**TOWN OF MOUNTAIN VILLAGE
DESIGN REVIEW BOARD
REGULAR MEETING
THURSDAY, JANUARY 7, 2016 10:00 AM
2nd FLOOR CONFERENCE ROOM, MOUNTAIN VILLAGE TOWN HALL
455 MOUNTAIN VILLAGE BLVD, MOUNTAIN VILLAGE, COLORADO
AGENDA
REVISED**

TO: Design Review Board
FROM: Dave Bangert, Town Forester
FOR: Meeting of January 7, 2016
DATE: December 22, 2015
RE: Consideration of a Design Review application for a new single-family dwelling on Lot 421

**RESOLUTION OF THE DESIGN REVIEW BOARD
OF MOUNTAIN VILLAGE, COLORADO, AUTHORIZING AND APPROVING THE DESIGN
REVIEW PROCESS FOR LOT 421**

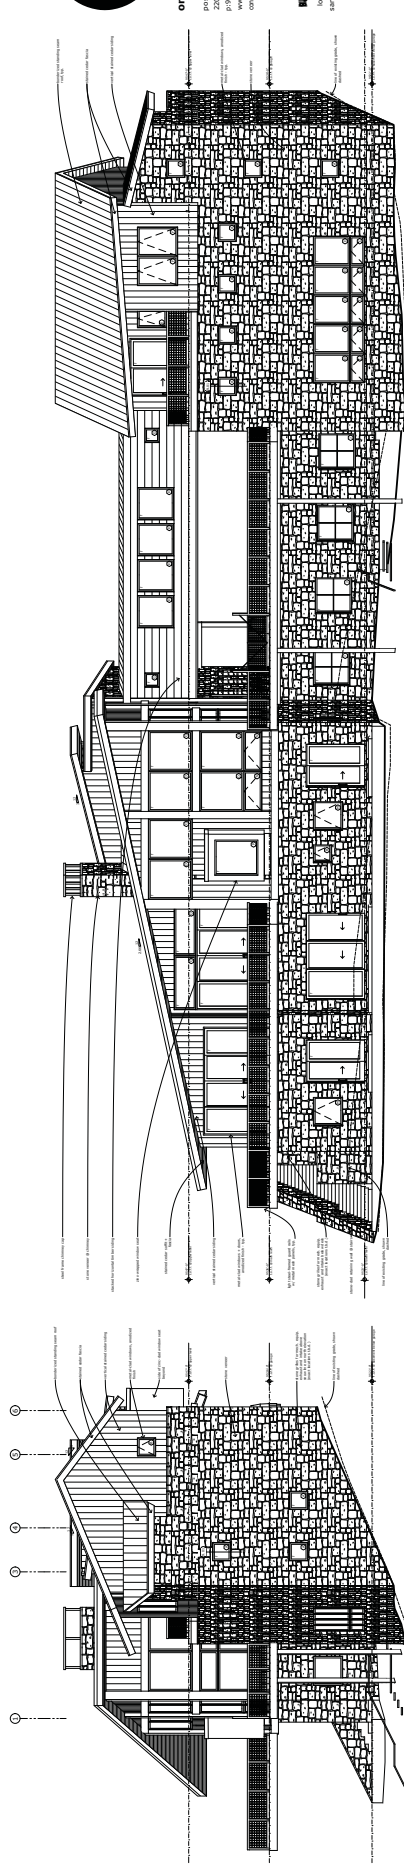
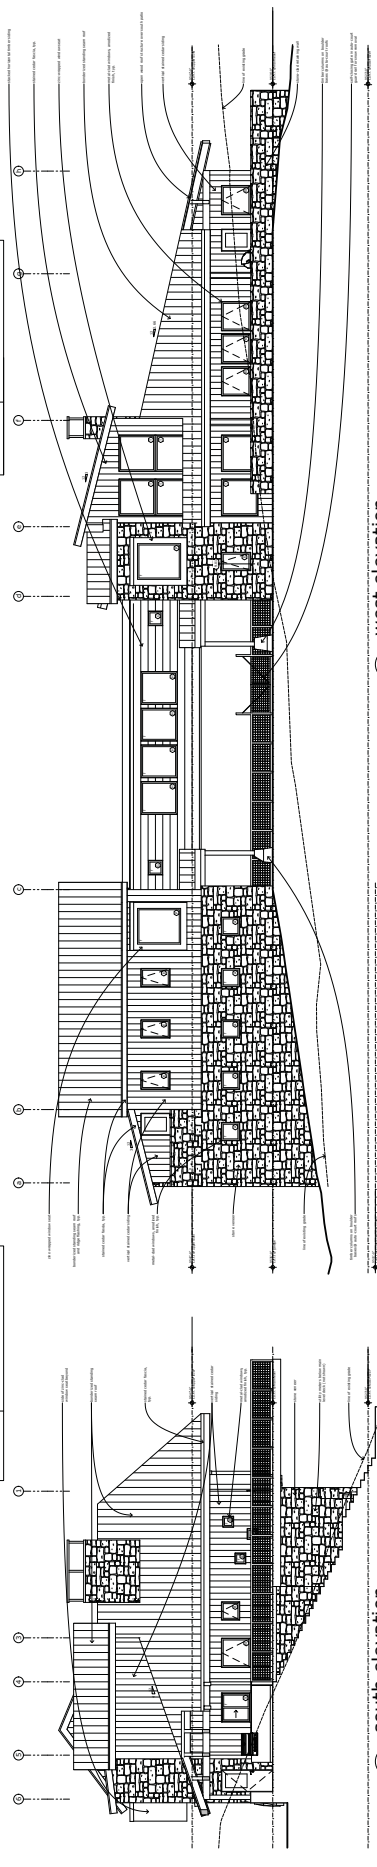
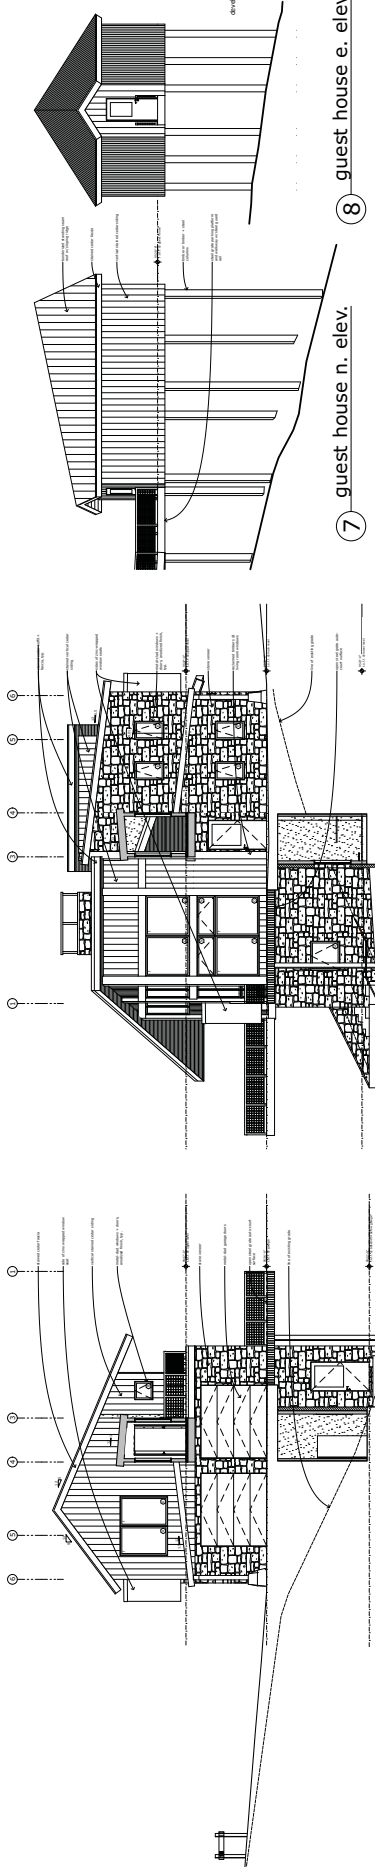
The CDC allows for primary roof pitches to be between 6:12 and 12:12 and be gable in form, and secondary roofs will not have pitches less than 4:12 and be either gable or shed in form. With this in mind, the roof plan illustrates that the two primary roofs do not meet the CDC requirement. One of the primary roofs is gable in form and has pitches of 5:12 and 9:12. The other primary roof is hip in form and has pitches of 2.66:12 and 4:12. The secondary roof pitches are 1:12, 1.5:12, 3:12 and 4:12.

- The applicant is seeking specific approval for the following design variation pursuant to CDC Section 17.4.11(E) (5):
 1. Proposed primary roof with a 5:12 pitch. Proposed primary roof, hip in form, with pitches of 2.66:12 and 4:12 as outlined in CDC Section 17.5.6.(C)(2)(a).

2. Proposed secondary shed roofs with 1:12, 1.5:12 and 3:12 pitches as outlined in CDC Section 17.5.6.(C)(2)(b).
- Section 17.4.11(E) (5) (e) states that the following criteria shall be met for the review authority to approve a design variation development:

The exterior walls consist of 40% stone; 30% wood siding; 3% zinc accents; and 22% fenestration. With a 40% stone coverage, the stone percentage meets the 35% minimum. Wood siding shall be a minimum size of one inch by eight inches (1" x 8") in dimension and stained. Zinc accents require a DRB specific approval:

The DRB should review the steel accents to determine if these elements are appropriate and compatible with the surrounding area development.
